FINAL REPORT

DIABLO CANYON UNITS 1 AND 2
PIPEWAY STRUCTURES

PACIFIC GAS AND ELECTRIC COMPANY

JUNE 1985

SKETCH NO. SKC-PW-01

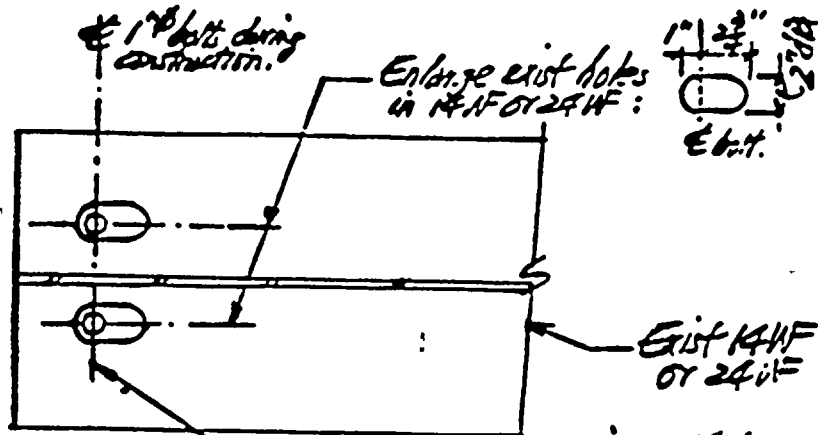
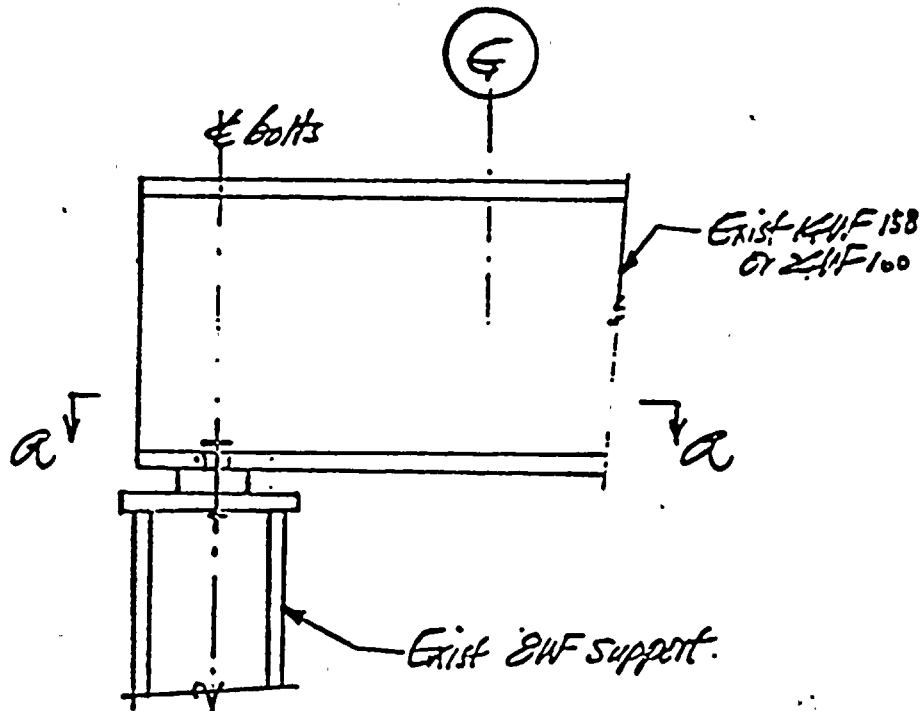
The Staff questioned the modeling of the slotted holes provided to allow for the relative motion between the pipeway structure and the auxiliary building. Their specific questions involved the nodes representing the connection of the pipeway structure to the auxiliary building being modeled as free nodes in both global horizontal directions. Similar modeling procedures were used for the end nodes of the radial beams of the pipeway structure which are framed into the turbine building.

- a. The connection detail for the north end of the tangential beams framing into the auxiliary building is as shown in Attachment A (Detail 1 on SKC-PW-01). This detail allows for free movement in north-south direction through the slotted holes with finger-tightened bolts. The oversize holes provide for a limited movement in the east-west direction. This condition, however, does not restrain the pipeway structure in the east-west direction because the connection at the south end of these beams uses clip angles on either side of the beam web. The tangential beams framing into the auxiliary building do not support the main steam and feedwater lines.
- b. The connection detail for the west end of the radial beams framing into the turbine building is as shown in Attachment A (Section A on SKC-PW-01).

Since the horizontal differential movement of the turbine building with respect to the pipeway structure is ± 0.17 inches in the north-south direction, and ± 0.24 inches in the east-west direction, the wide slots provide more than sufficient clearance to assure the boundary condition assumptions are representative of as-built conditions.

Figure E-1

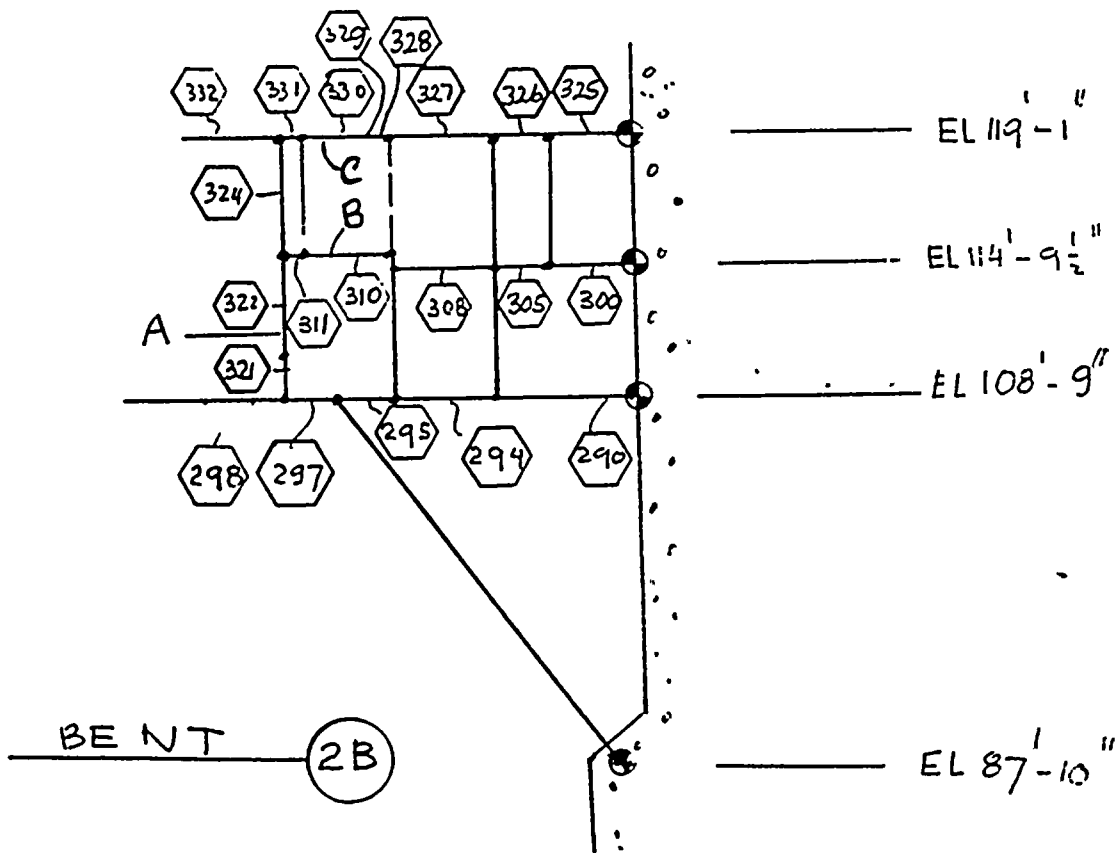
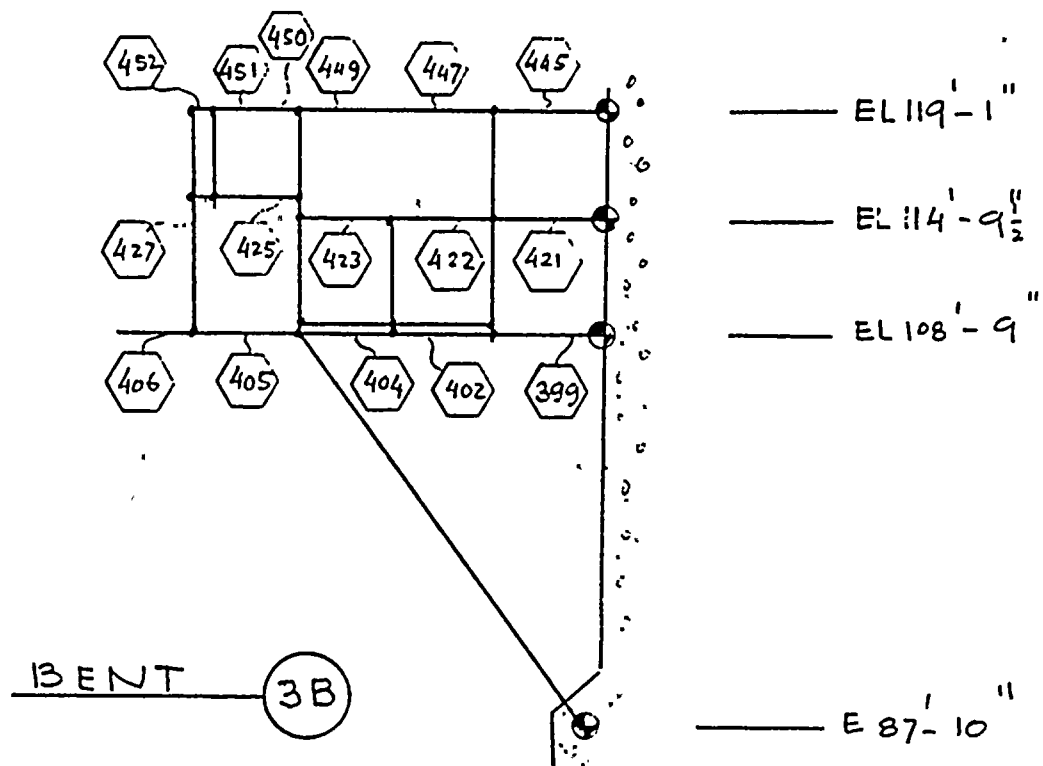
Since the design of structural members of the pipeway structure could be controlled by the DE or DDE in combination with other loads, the Staff requested that an evaluation be performed for these load combinations.

There are two radial bents which are highly loaded by Y_r and by H_{osgri} , bents 2B and 3B. The calculations performed for the purpose of evaluating the effect of combining DE/DDE and pipe rupture loads are for these bents.

Figure 1

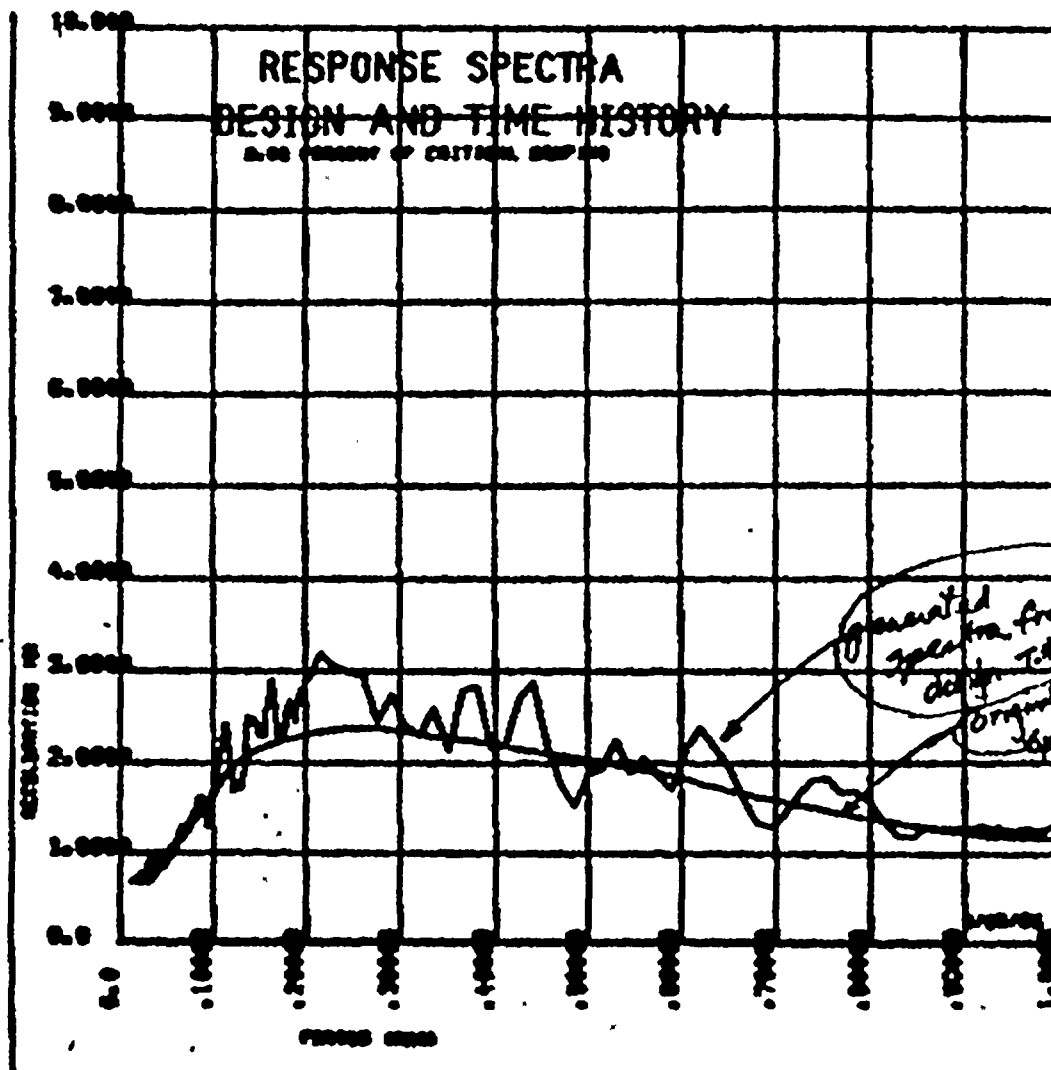
1. QUESTION: Does the 2% spectra generated from the design time-history (with $\Delta T = 0.01$ sec) envelop the design response spectra in the high frequency region?

Attached is a Blume spectra for 2% damping (Figure 1) generated from the 24-second design time-history provided by PGandE with $\Delta T = 0.01$ seconds. From the figure, it is seen that there is a good match in the high frequency region ($f > 12$ Hz). Therefore, the design time-history used in the analysis is considered adequate.

Figure 2

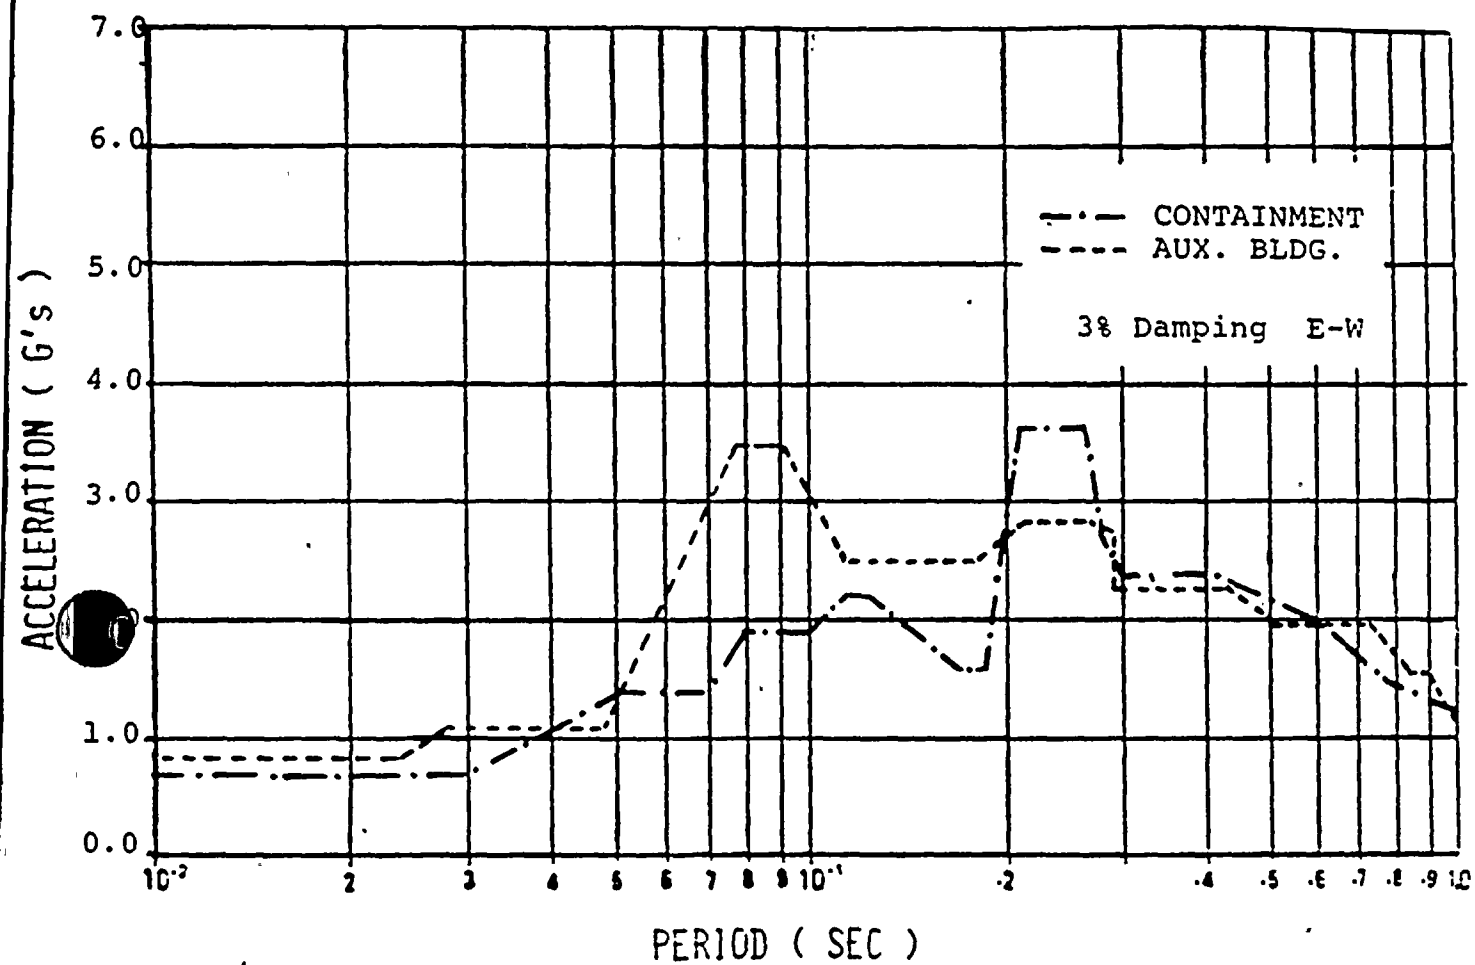
2. QUESTION: In the response spectra of the pipeway structure, the auxiliary building motion at snubber locations of main steam and feedwater lines are assumed to be the same as the containment building input motion. How does this assumption affect the response spectra generated in the pipeway structure?

- b. The frequency calculation from a cantilever beam analogy of this pipe with a 48.4-foot span yields a fundamental mode of 2.94 Hz. A review of applicable auxiliary building and containment shell spectra (Figure 2) indicates that the containment spectra envelopes the auxiliary building at a frequency of 2.94 Hz. Furthermore, the frequency of 2.94 Hz is not close to the amplified frequencies in the auxiliary building, $f > 11$ Hz.

BLUME/NEWMARK SPECTRA
(2% AND 7% DAMPING)

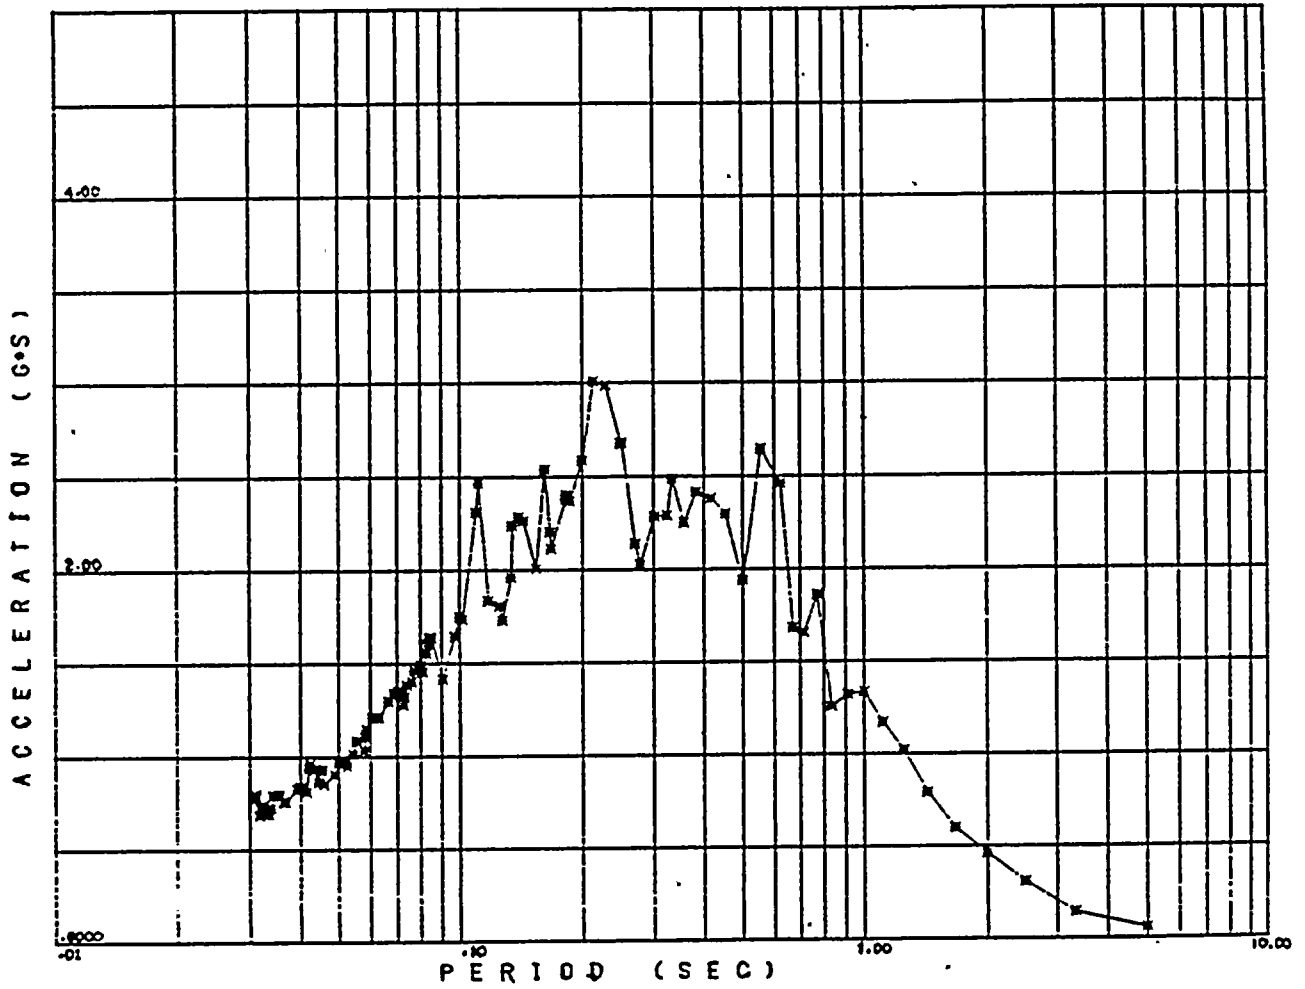
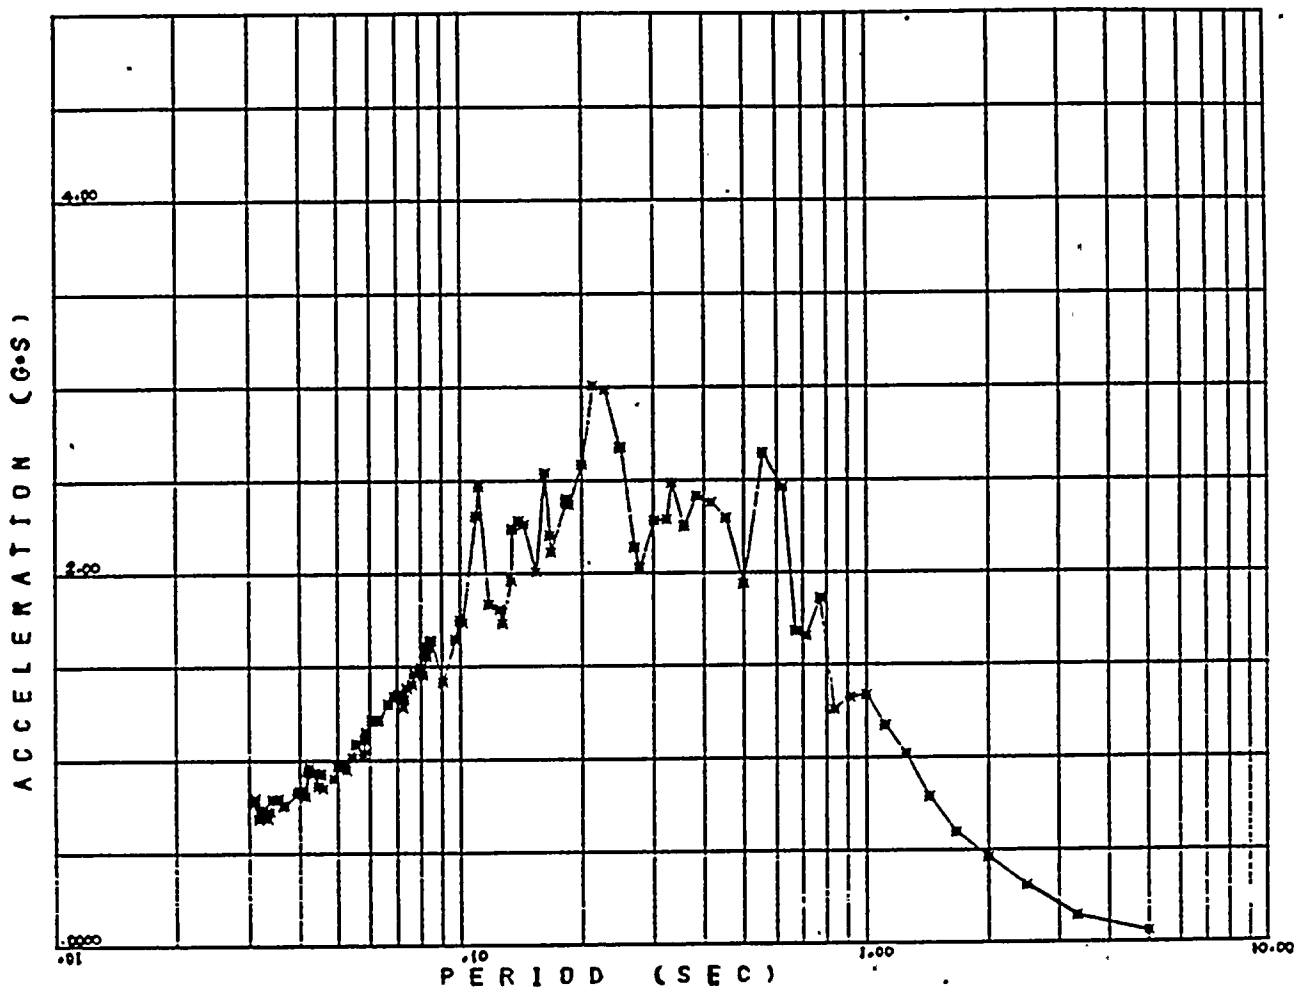
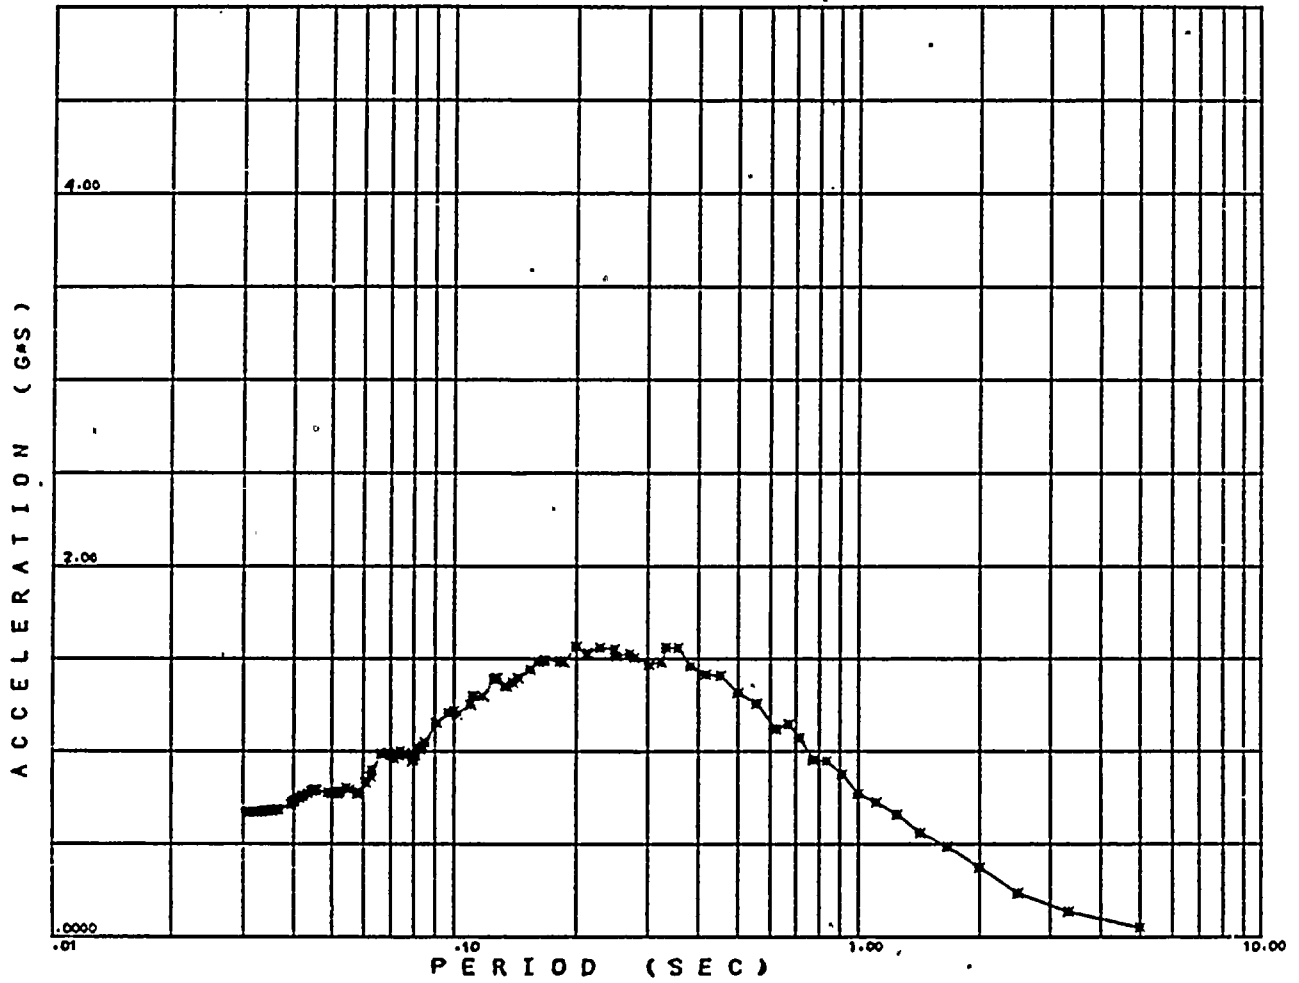
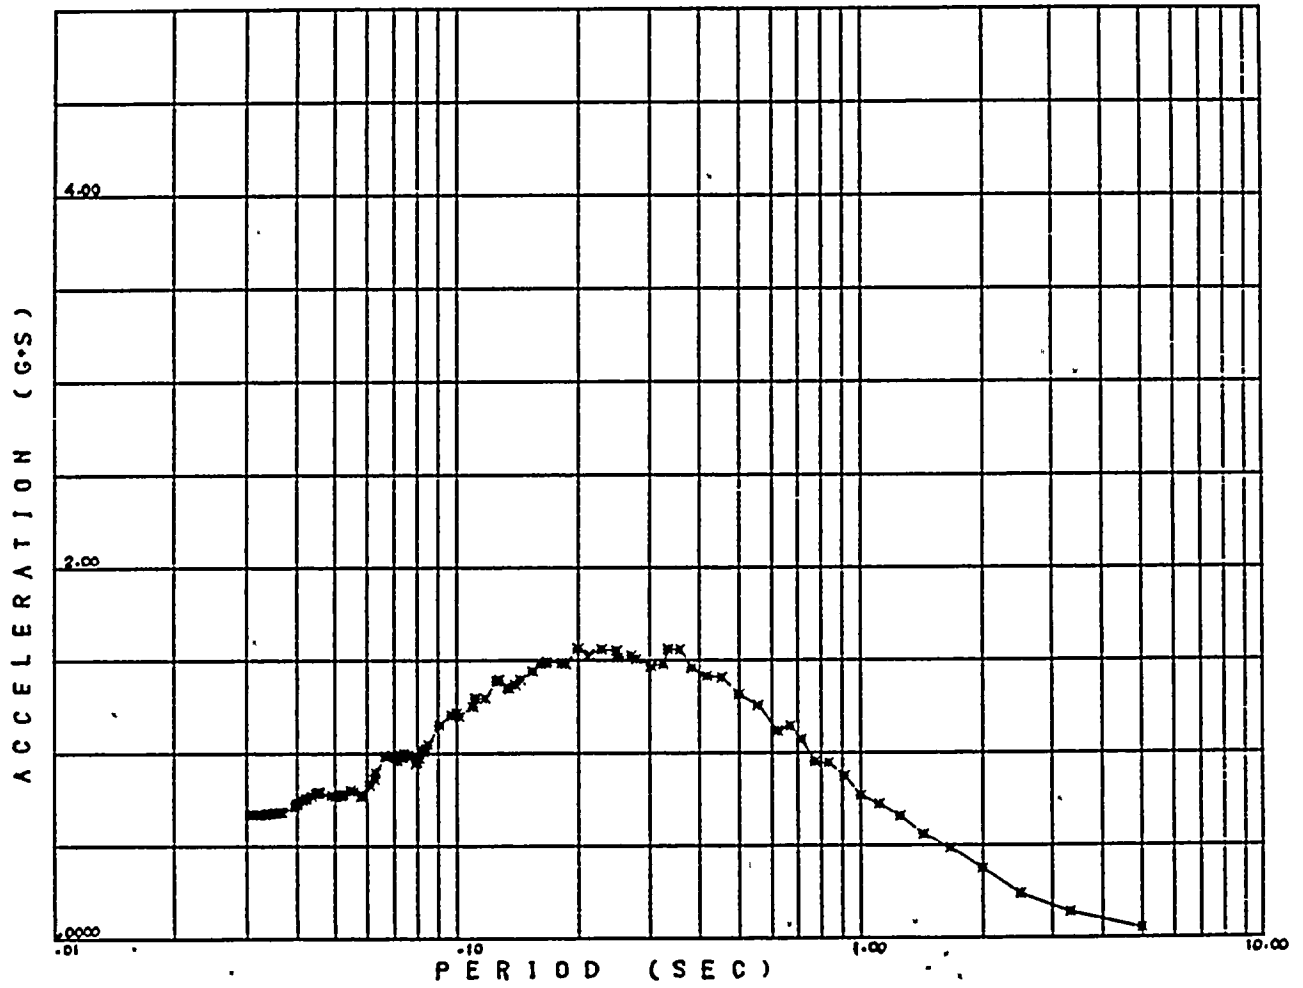
After receipt of the audit followup information discussed above, the Staff requested additional information on Calculation No. 1149C-1, Rev. 0 and pipeway response spectra for 2% and 7% damping generated using two distinct integration time-steps. This information was sent to the Staff on March 18, 1985, and is reproduced in Appendices 3 and 4.
